## Ecological Design Evolution Document

Land South of Dearne Valley Parkway, Goldthorpe

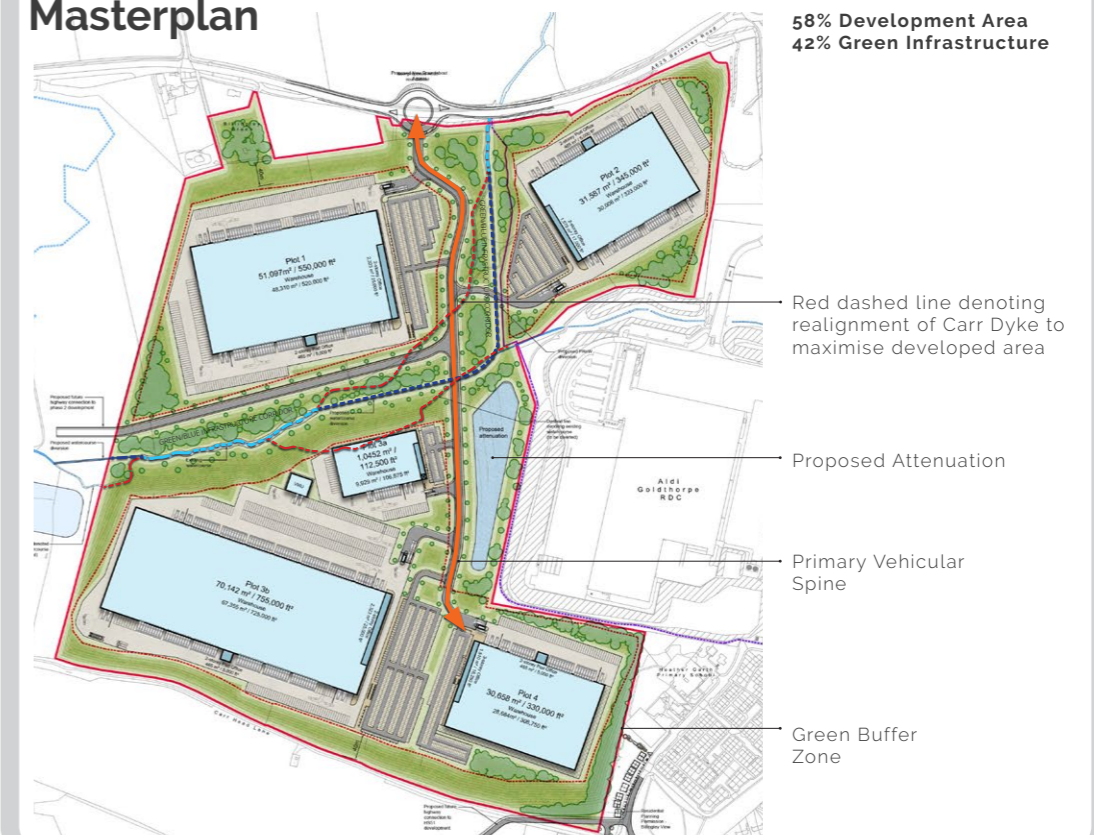
Earthworks/Bunding/Cut and Fill

- Tom Lonsdale noted that without further detail on the three-dimensional representation of the site, topography and earthworks strategy, it was difficult for the panel to pass more detailed comment as the section where considered to be too conceptual/diagrammatic.

Flood Compensation

- There appeared to be a lack of knowledge on flood compensation storage and how this is a perfectly acceptable solution to developing within the flood zone.

- Earthworks and bunding has been considered and incorporated. Please refer to Structural Engineer and Civil Engineer drawings.

- Flood compensation areas have been included within the design, including the additional land the the western boundary. Please refer to FRA Statement.

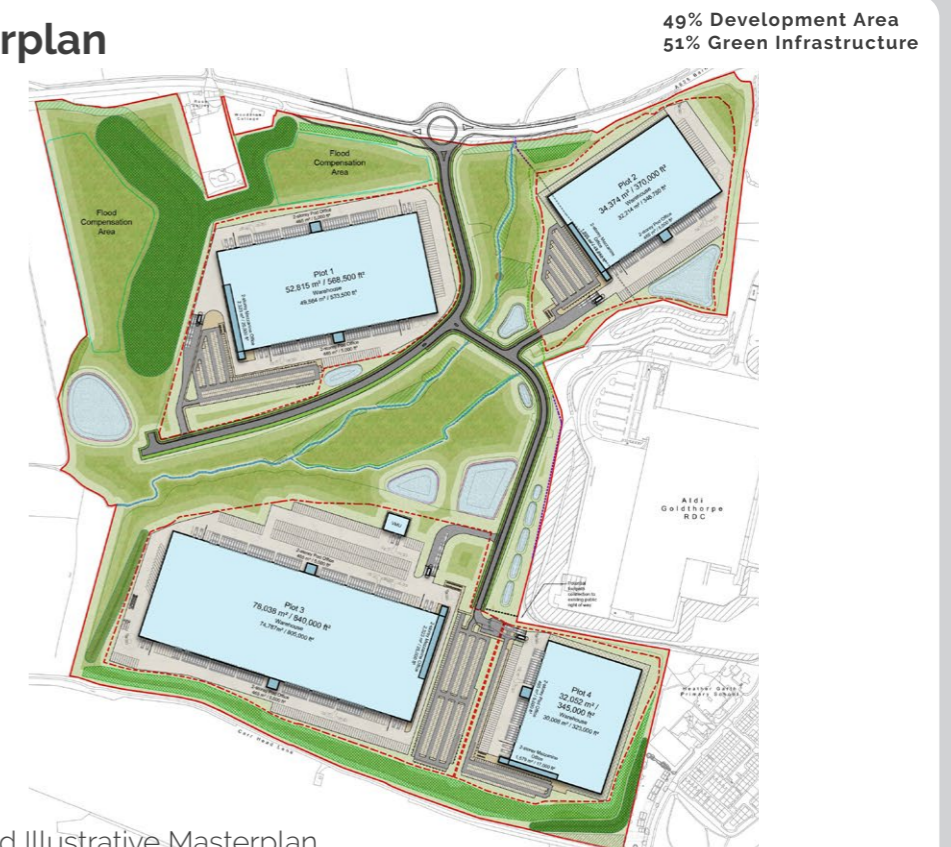
- Siting | 4 development platforms.
- Landscape | Retain existing woodland and hedgerows on site periphery and hedgrow in the north-west corner of the site.
- Green Infrastructure | Retention of Carr Dyke and creation of habitat corridor (at least 8m in width).
- Biodiversity Net Gain | Achieve at least 10% BNG.

- 4 development plots created on 3 plateau areas.
- Existing vegetation to be protected where possible.
- Carr Dyke retained and deliver a corridor width of between 50-80m.
- Achieve a minimum 10% BNG through on and off-site provision.

Landscaping Plan

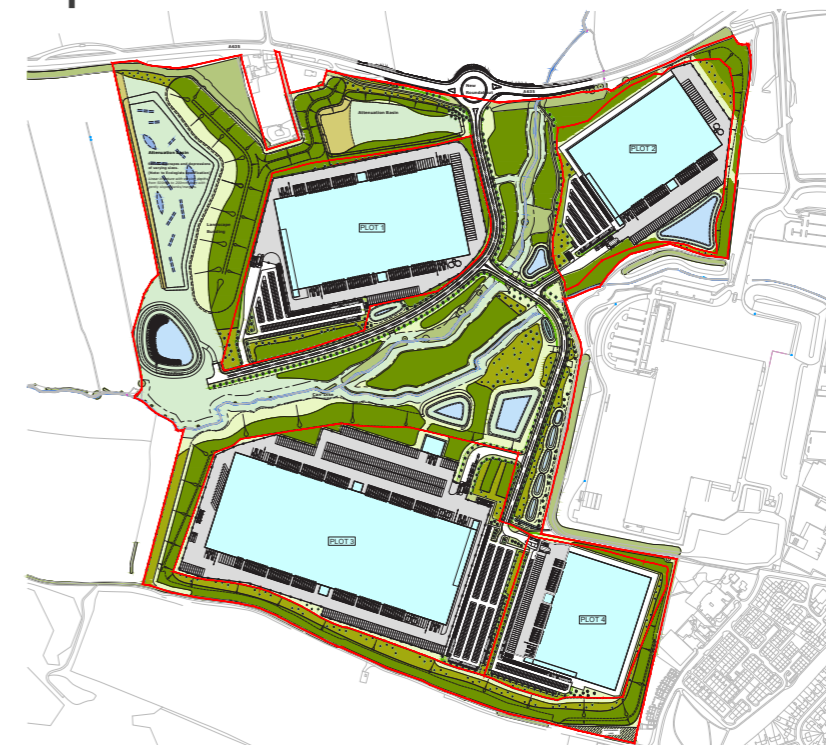
Yorkshire Wildlife Trust:

- Provision of mitigation for ground nesting birds, willow tits,

- Retain T15

- Provide mammal ledges
- Avoid artificial bank enhancements
- Utilise stone headwalls
- Provision of mitigation for marsh harriers and breeding/wintering birds

- Provision of mitigation for willow tit, marsh harrier and wintering birds

- Compensation of flood within Site

- Amend levels adjacent to plot 2
- Provide level access cycle route

- Reduction in proposed woodland and scrub providing more open grassland habitat in west promoting use by birds (inc. Marsh Harrier)
- Reduction in proposed woodland and scrub along the south-west Carr Dike corridor – opening up known areas of marsh harrier activity.

- Provide scrapes within flood attenuation area promoting a diverse wet grassland structure suitable for a range of birds (inc. marsh harrier), small mammals, and amphibians.

- Flood attenuation basins managed as damp tussocky grassland; diverse structure, high quality habitat for a range of bird species including farmland birds and ground nesting species.

- Manage woodland areas to promote willow tit, creating diverse woodland structure with introduced dead wood for foraging and nesting.
- Manage edges of the flood attenuation basins providing small seed bearing plants for additional foraging for farmland and overwintering birds.

- Provide supplementary feeding for wintering birds in the west and north flood basins using seed and feeders where appropriate.
- Provide fruit bearing trees through the development for winter bird foraging (inc. some farmland birds e.g. redwing, fieldfare, starling)

- Provision of a range of bird nest boxes across the development appropriate for farmland birds located appropriately to avoid willow tit habitats.
- Provision of mammal ledges or mammal underpasses on watercourse crossings ensuring connectivity for otters, badgers and small mammals.
